Docket Number:	13-AFC-01
Project Title:	Alamitos Energy Center
TN #:	201751
Document Title:	Data Adequacy Supplement
Description:	N/A
Filer:	Elizabeth Smoker
Organization:	CH2M HILL
Submitter Role:	Applicant Consultant
Submission Date:	2/17/2014 1:21:17 PM
Docketed Date:	2/18/2014

**Re: Alamos Energy Center (13-AFC-01)
Data Adequacy Supplement**

Data Adequacy Supplement

**Alamitos Energy Center
(13-AFC-01)**

FIGURE DA3.0-1d
General Arrangement Third Quarter 2022
 Alamos Energy Center
 Long Beach, California

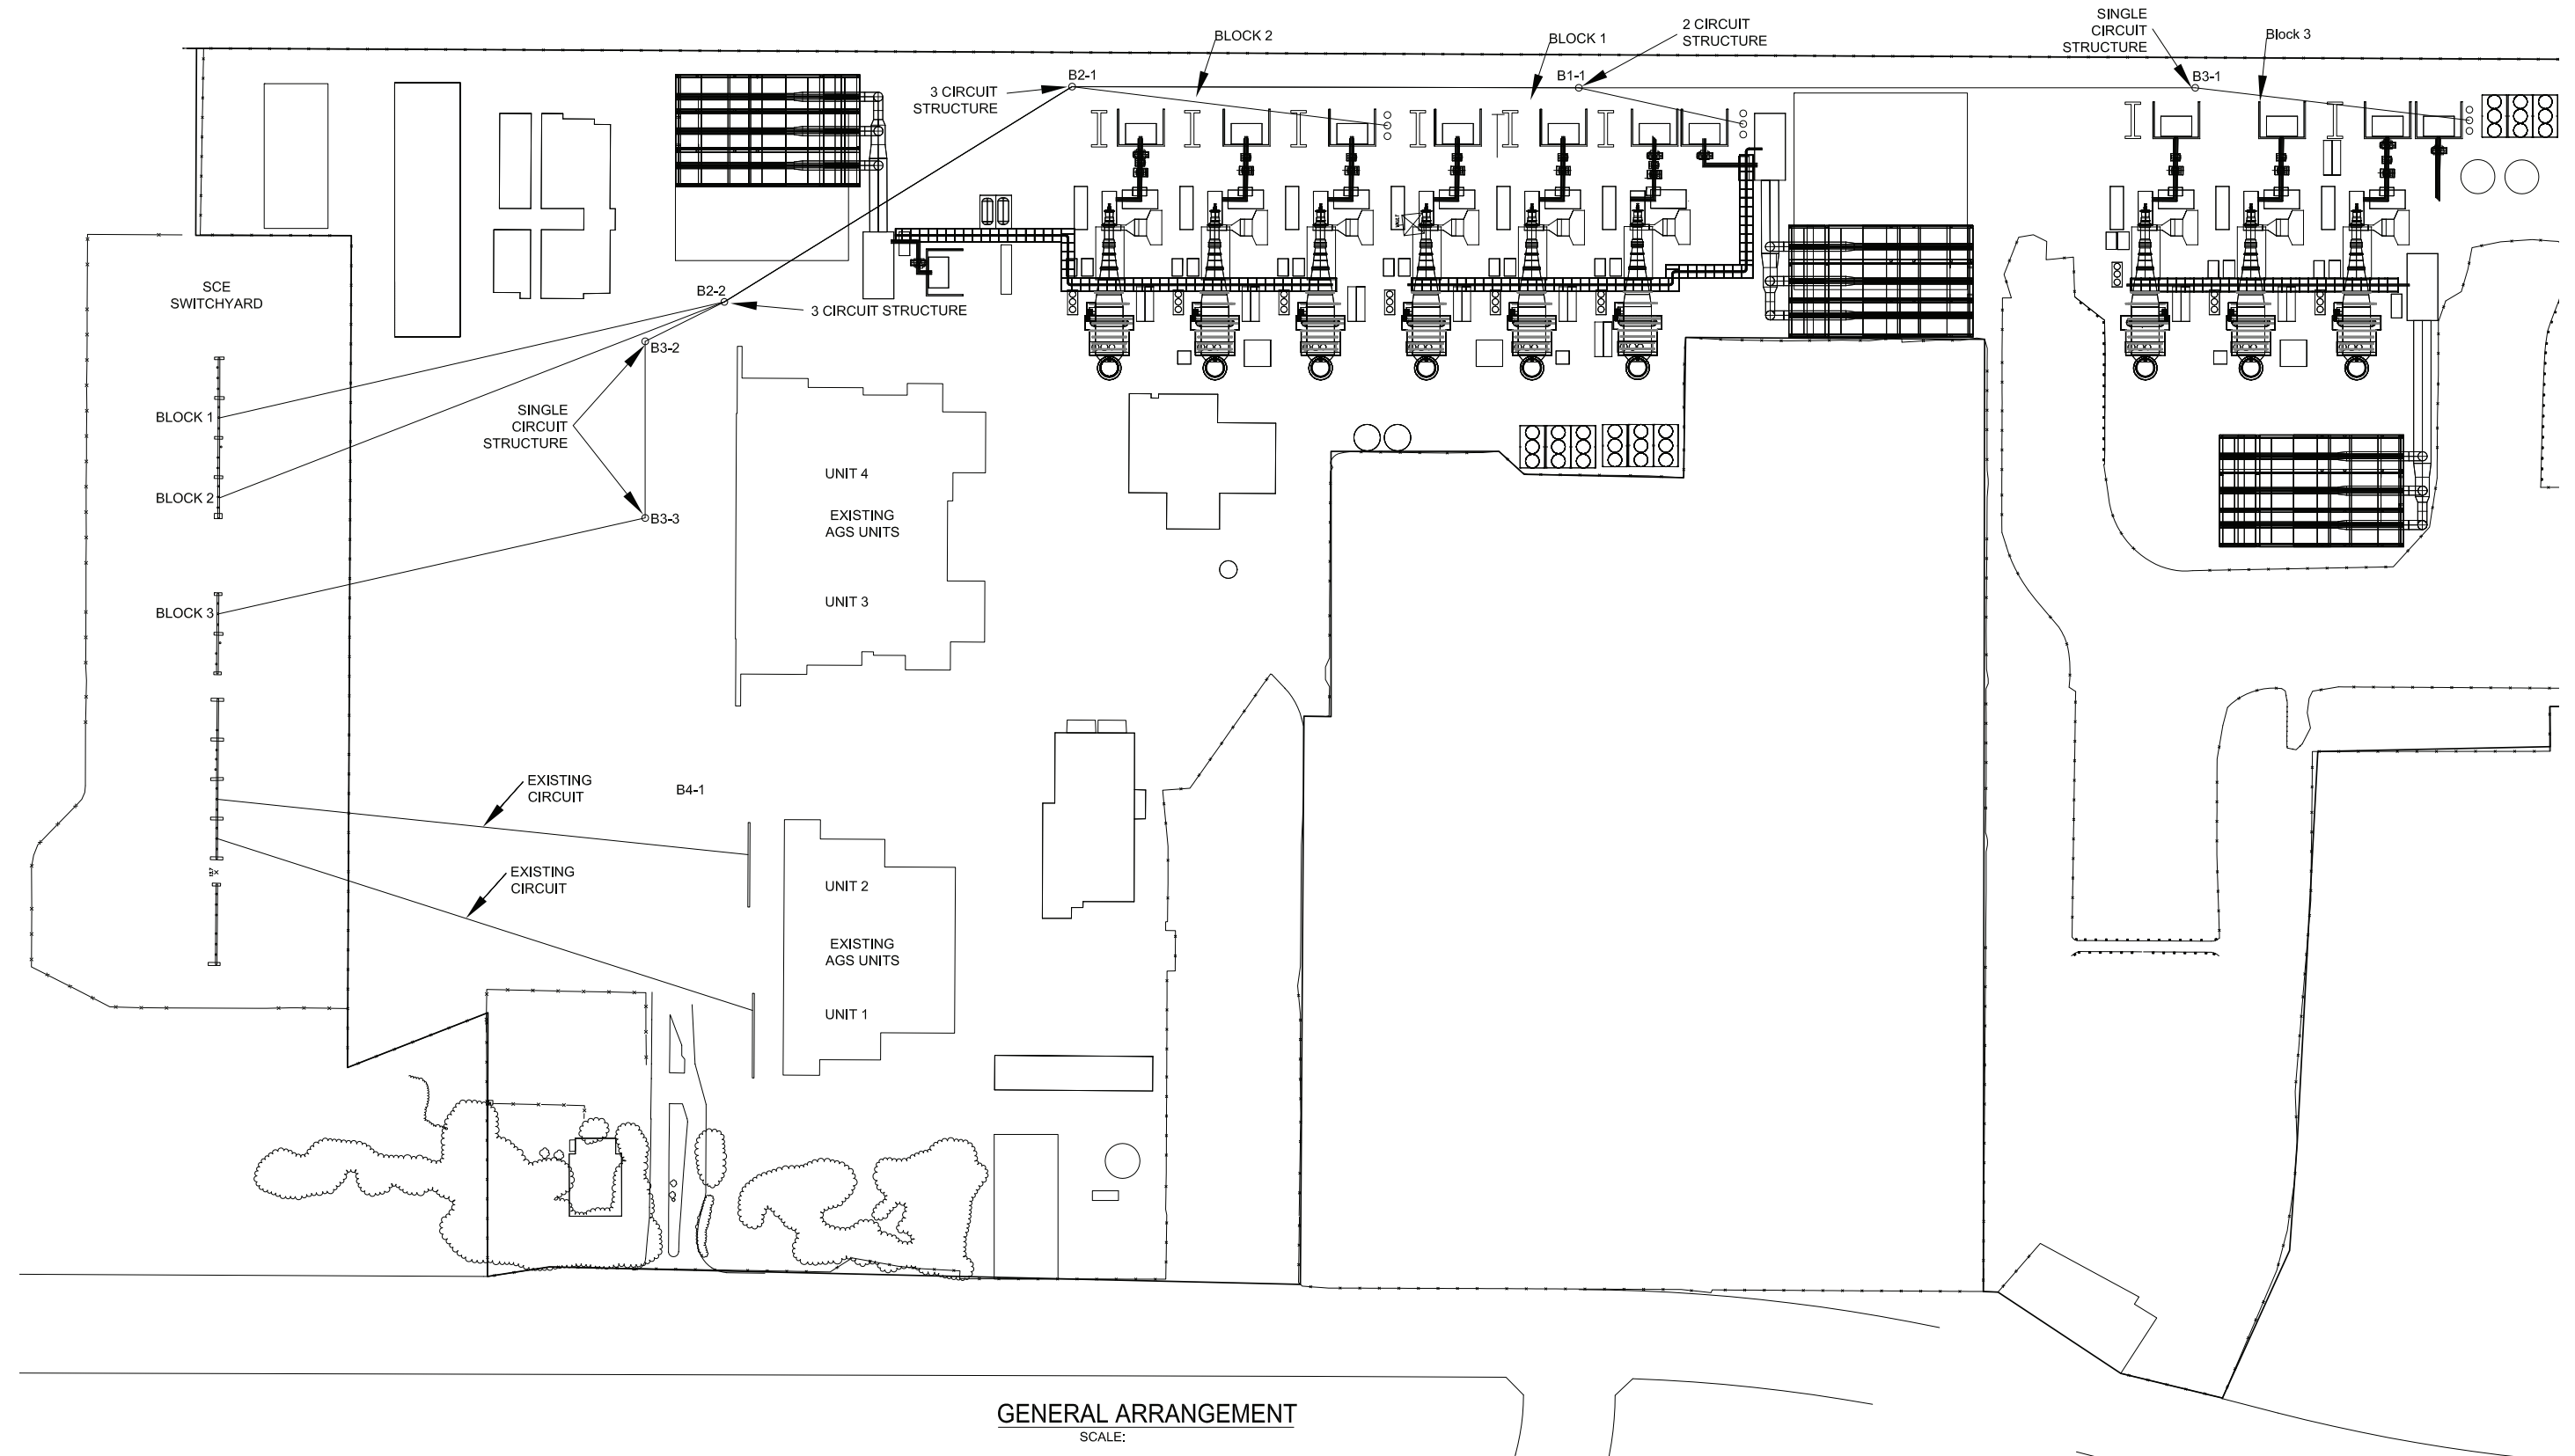
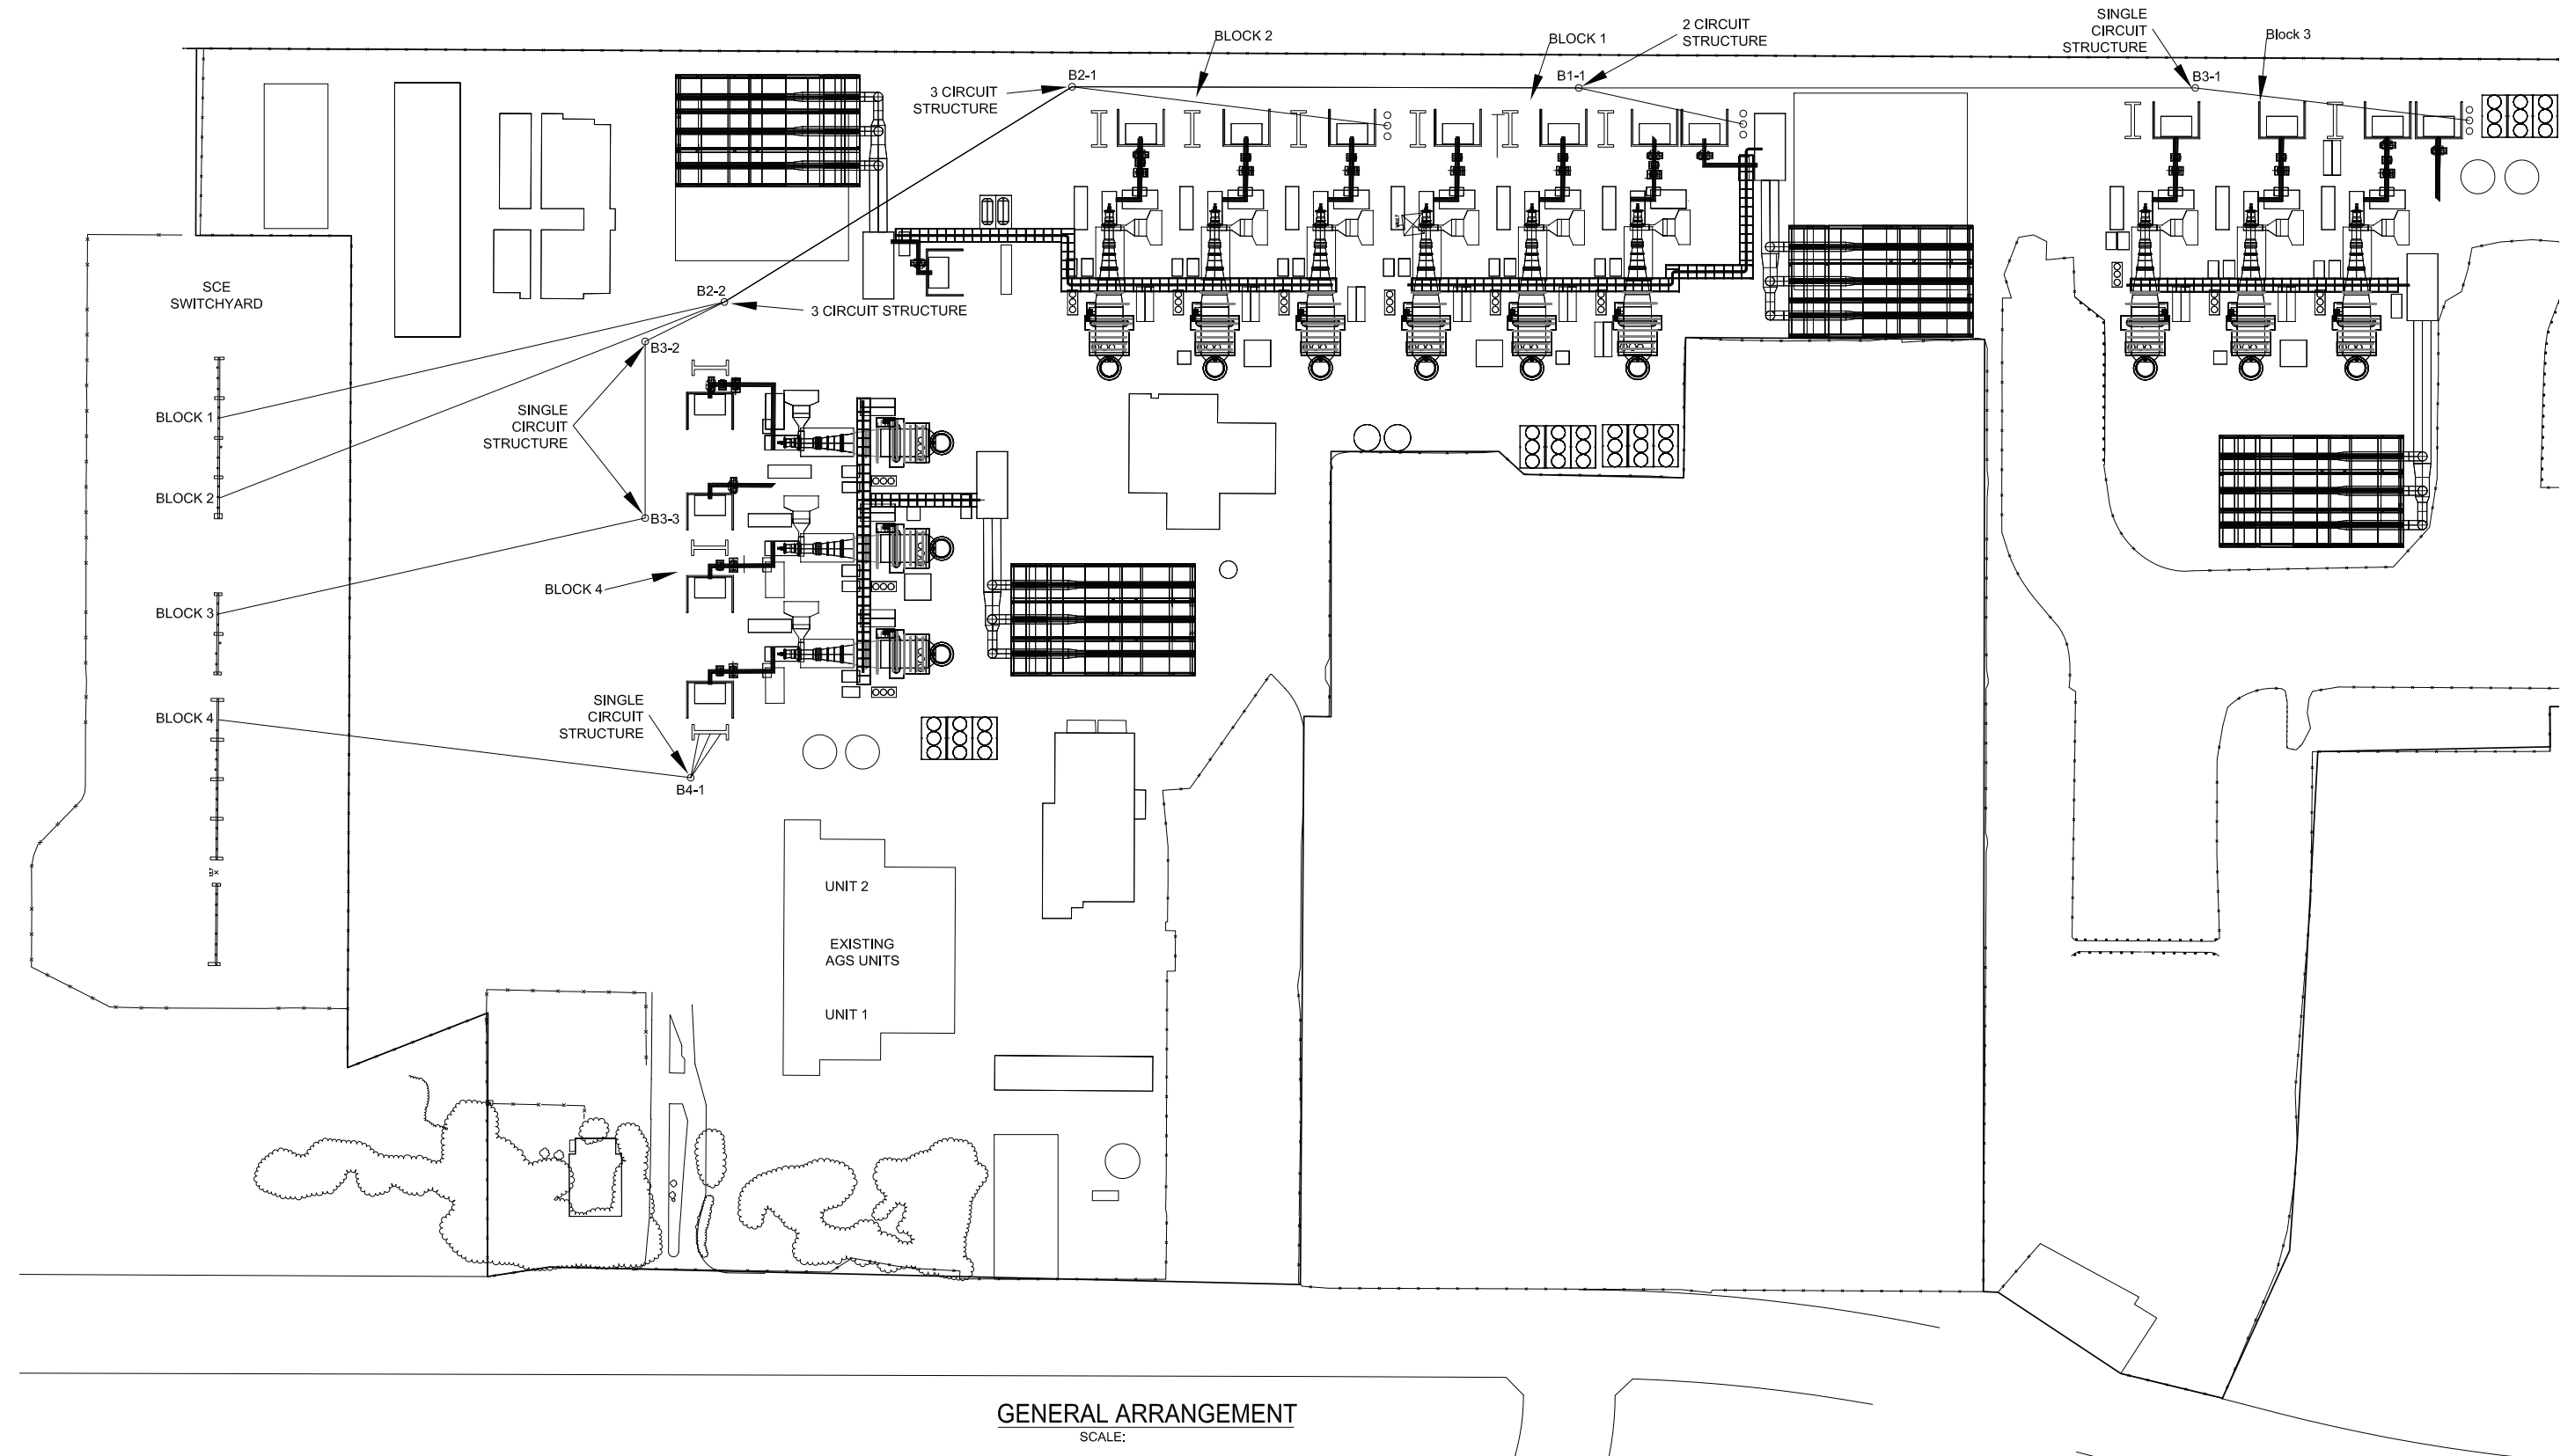
Submit three sets of pre and post-project physical layout drawings of the plant (similar to Fig. 2.1-2) according to the Table 2.2-1 project schedule with three major milestone dates which are: second quarter of 2019, third quarter of 2022, and fourth quarter of 2025.

Attachment DA3.0-1 includes three sets of the five physical layout figures at select stages of AEC's construction. Figure DA3.0-1a shows the existing site and electrical interconnections prior to construction. Figure DA3.0-1b, representing the second quarter 2016, shows the existing site with Unit 7 demolition completed and the rerouting of the Alamitos Generating Station Units 5 and 6 interconnection line completed. Note that all three of Units 5 and 6 interconnection towers are replaced by transmission towers that will ultimately be used by AEC's Blocks 1, 2 and 3. Figure DA3.0-1c, representing the second quarter 2019, shows AEC Blocks 1 and 2 interconnected to the SCE switchyard using the transmission towers installed previously. The interconnection line for Units 5 and 6 is not shown on this figure as these units are scheduled for demolition starting in August 2018. Figure DA3.0-1d, representing third quarter 2022, shows AEC Block 3 interconnected to the SCE switchyard, again using the transmission towers previously constructed. Figure DA3.0-1e, representing the fourth quarter 2025, shows AEC Block 4 interconnected to the SCE switchyard.
